**SUBJECT:** NuScale Power, LLC Supplemental Response to NRC Request for Additional Information No. 38 (eRAI No. 8838) on the NuScale Design Certification Application

## **Response to Request for Additional Information Docket No. 52-048**

**eRAI No.:** 8838

**NRC Question No.:** 03.08.04-1

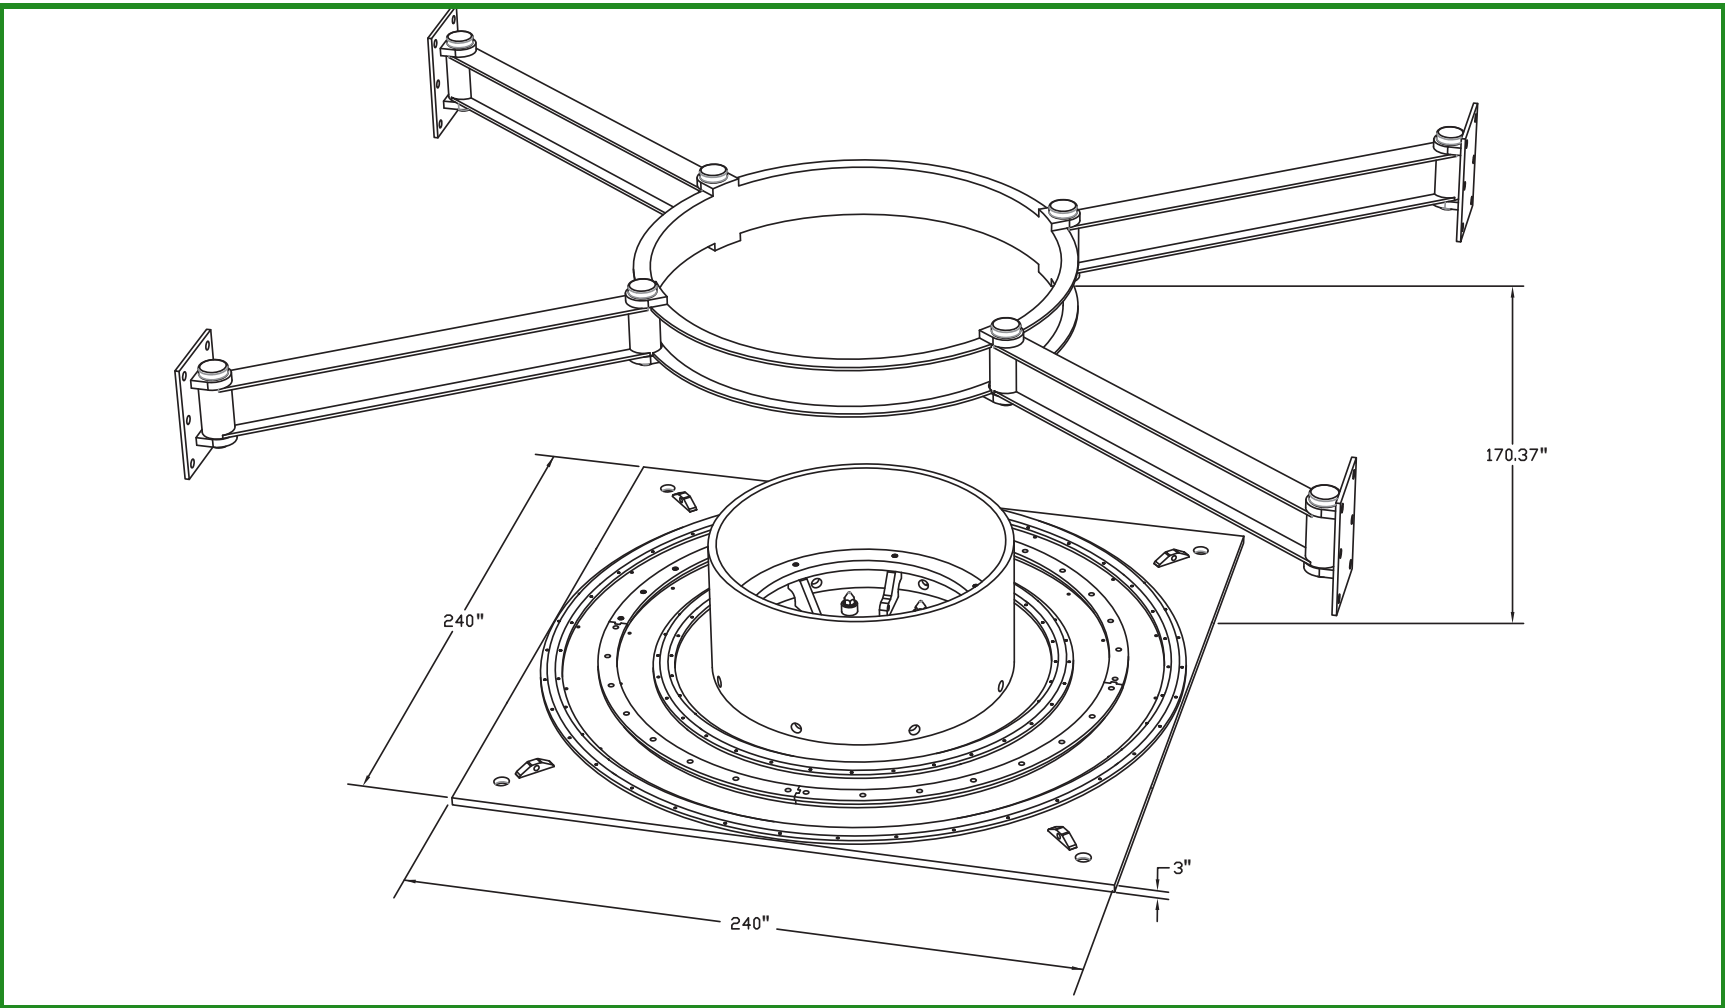
**8. Staff Feedback** - Provide a summary of results for the RFT stand and embedded plate in the FSAR such as demand, capacity/allowable limits, and associated demand over capacity ratios.

**Response** - The RFT embed plate results are summarized in FSAR Table 3.8.4-21. The RFT structural member results are summarized in FSAR Table 3.8.4-22.

**Figure 3.8.4-34: Reactor Flange Tool Support and Stand**

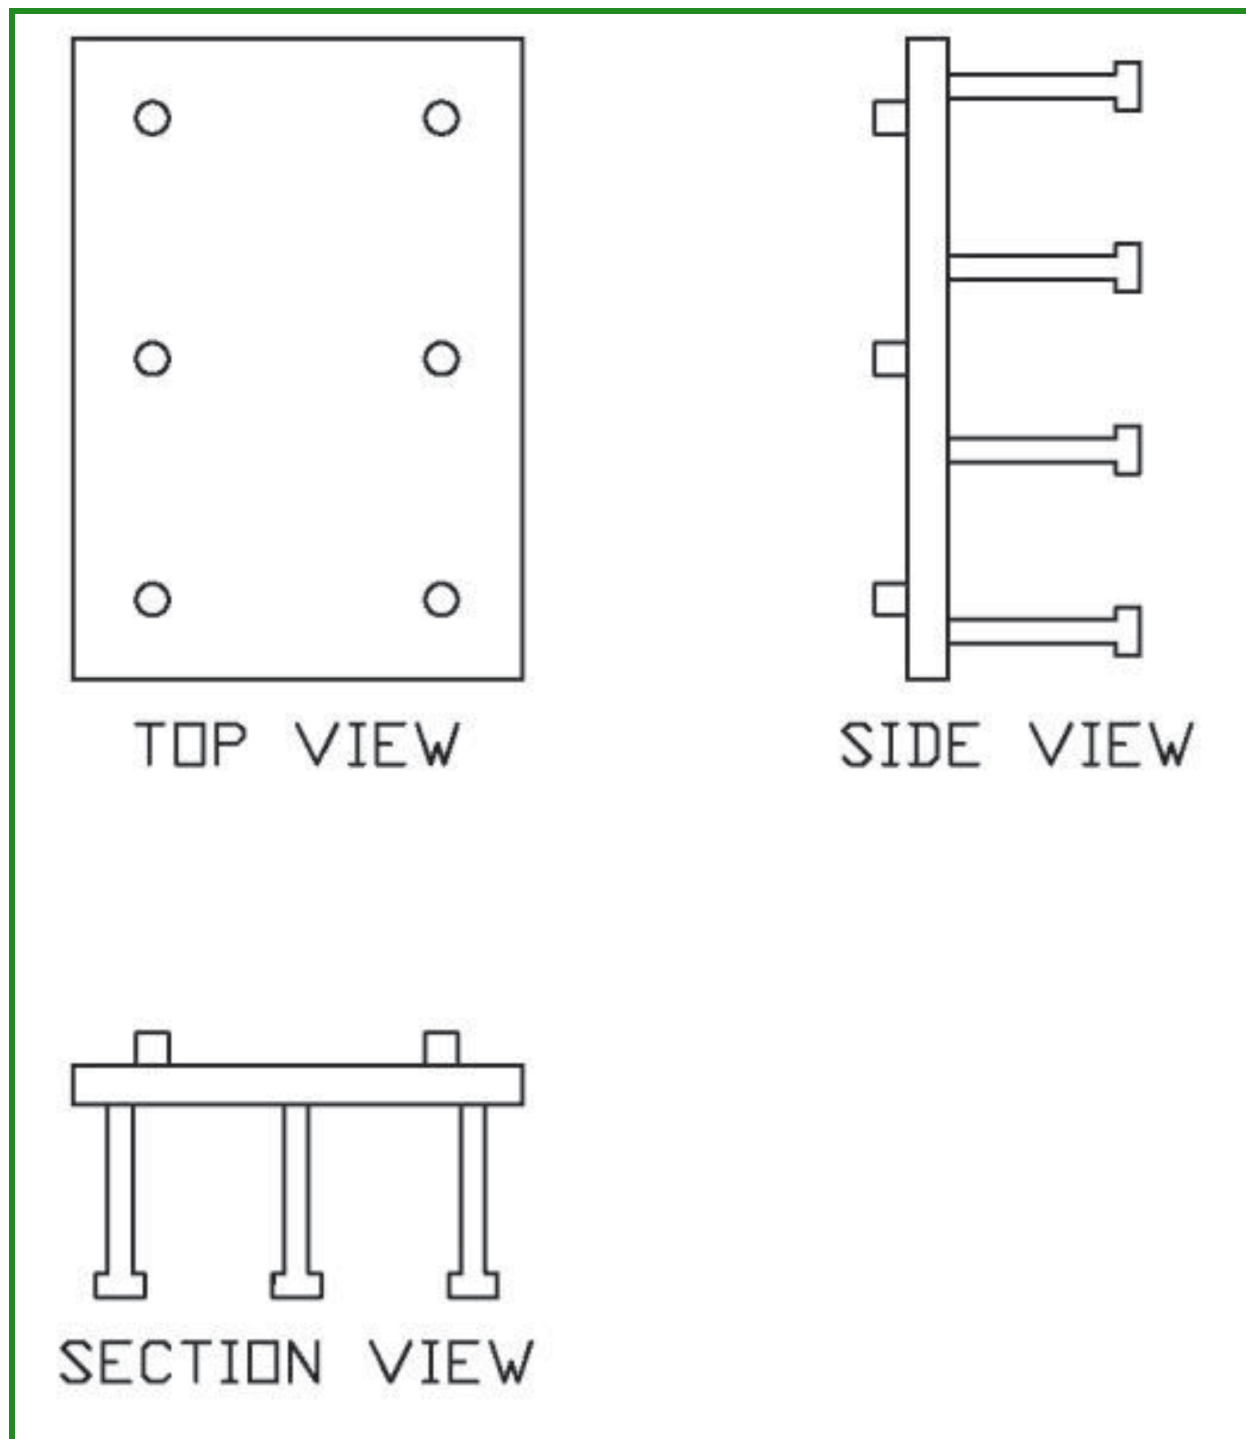
**9. Staff Feedback** - Provide FSAR figures addressing the RFT stand and embedded plate analysis model and RFT stand and embedded plate design including dimensions (e.g. plates, bolts, welds, concrete anchors, etc...) and materials.

**Response** - Figures of the RFT stand and embedded plate have been added as FSAR Figures 3.8.4-34 through 3.8.4-36.

Figure B-34 RFT Model ISRS, top of lower core plate, location 16, X-Direction (east-west)

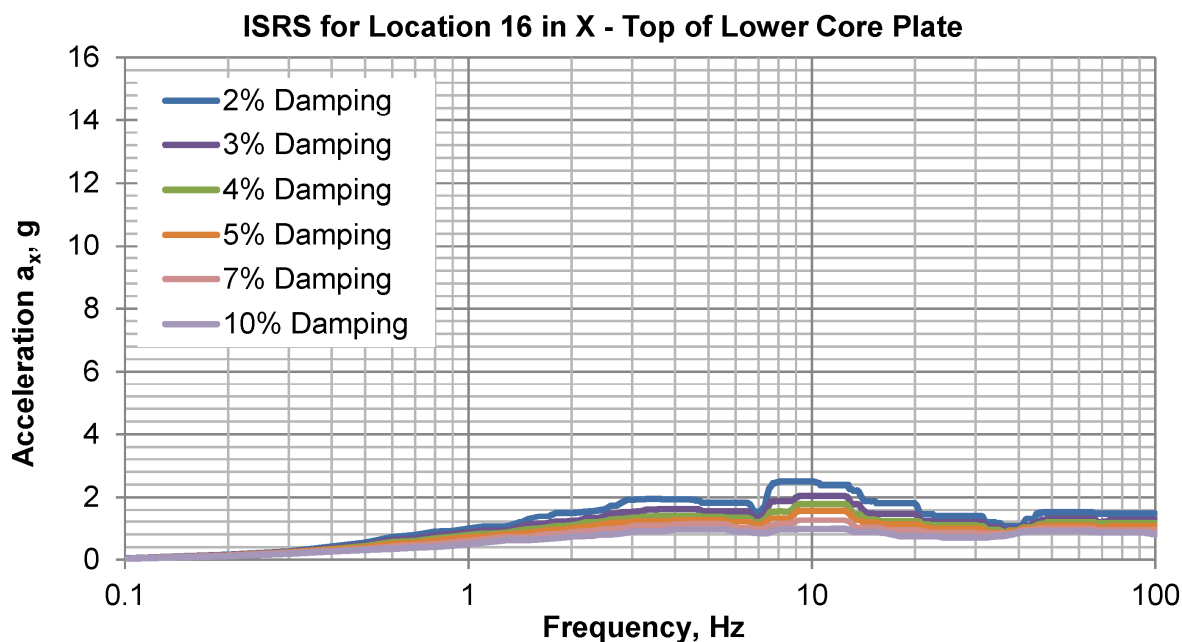
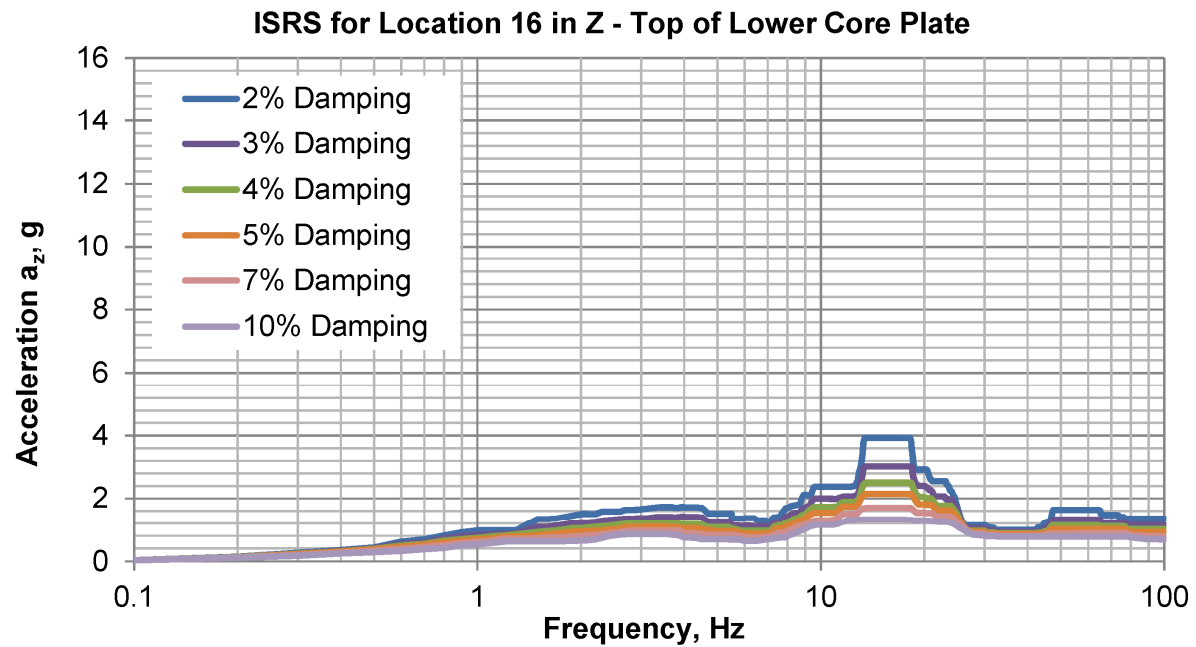
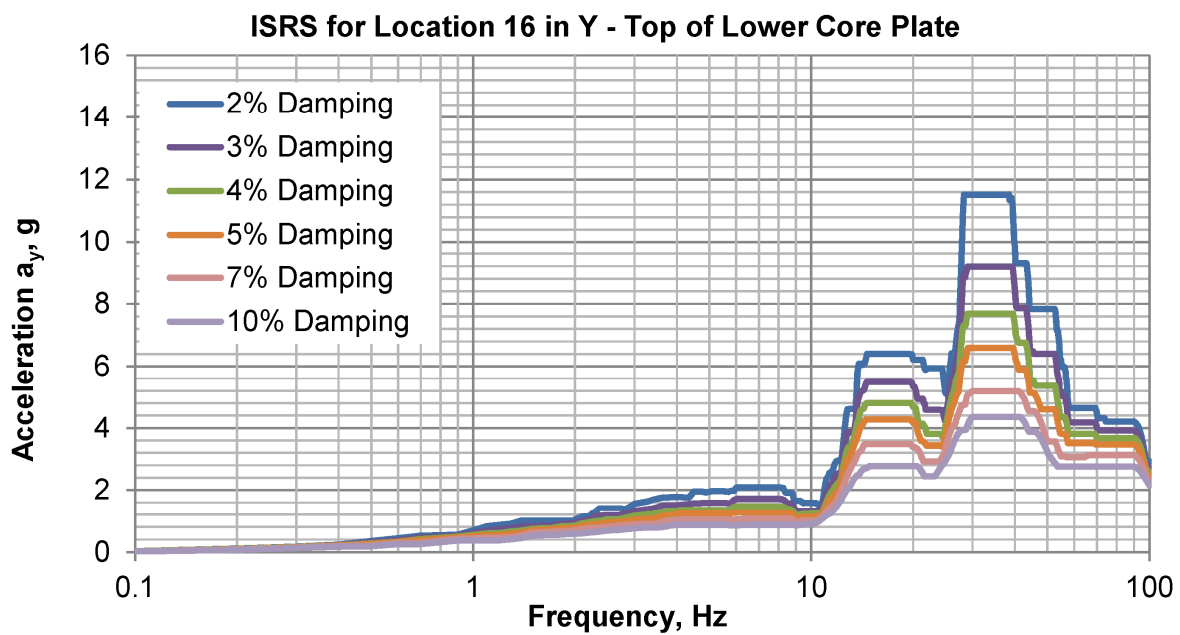
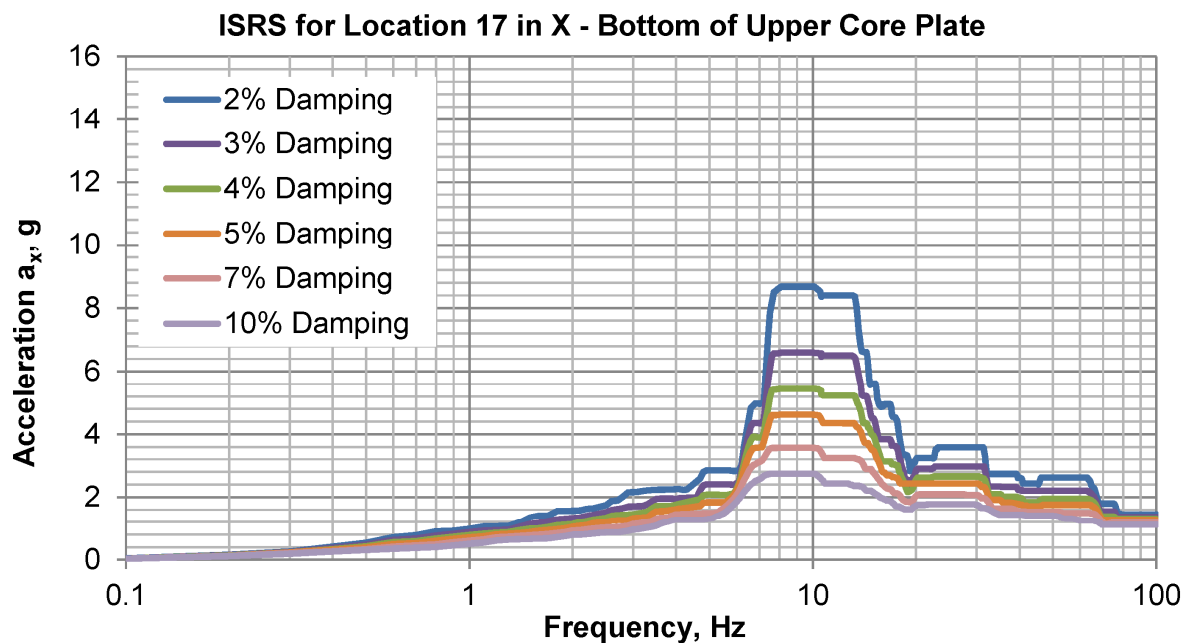
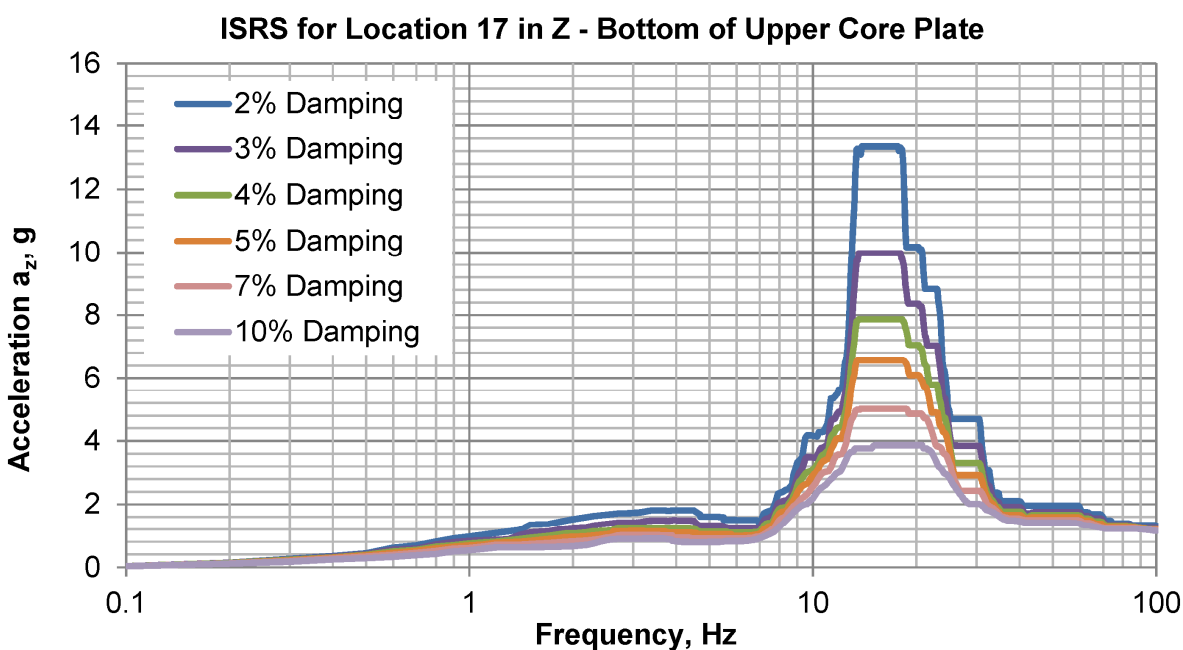
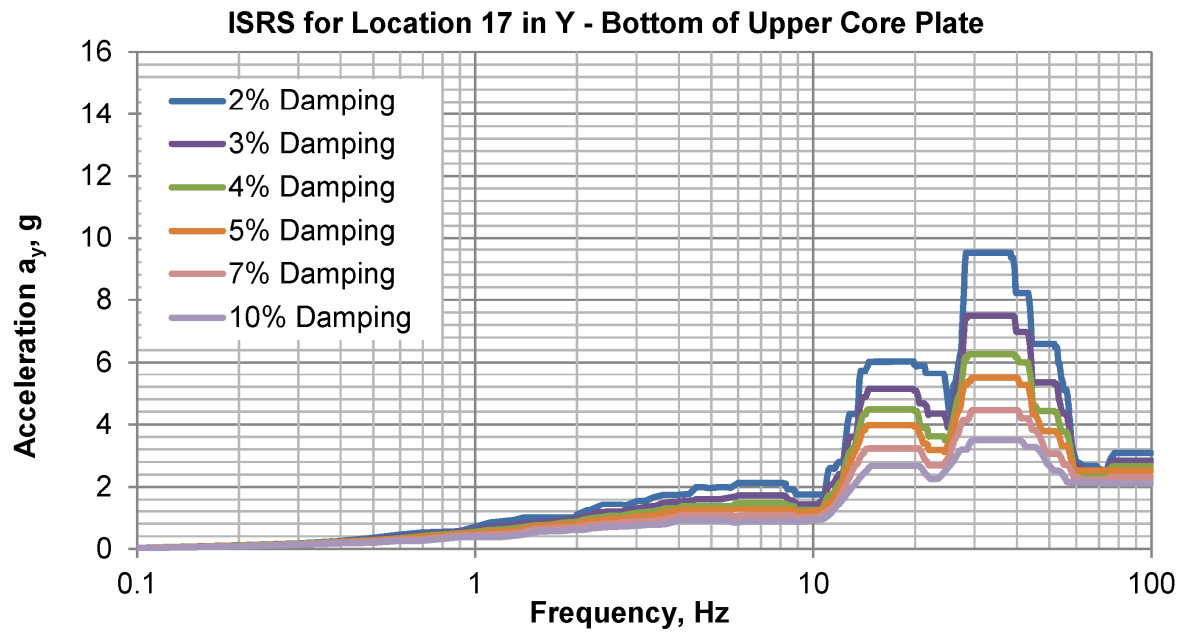
**14. Staff Feedback** - Describe consideration of lower RPV uplift and uplift magnitude if any and confirm that the RPV uplift effects have been addressed in the determination of the design demands for the pertinent structural components, as applicable.

confirmed by assessing demand-to-capacity ratios for the load combinations in Table 3.8.4-1 and Table 3.8.4-2, and applicable design codes in Table 3.8.4-12. In addition, the core plate in-structure response spectra for the RFT location shown in Figure B-34 through Figure B-39 of TR-0916-51502 (NuScale Power Module Seismic Analysis) shall be confirmed against the site specific spectra. If either the demands on the structural members or the embed plates exceed their capacity, or core plate motions do not maintain justifiable margin to limits for the fuel assembly, the COL applicant will address and augment the design per the criteria specified in FSAR Section 3.8.4, and the fuel assembly-imposed load limitations.
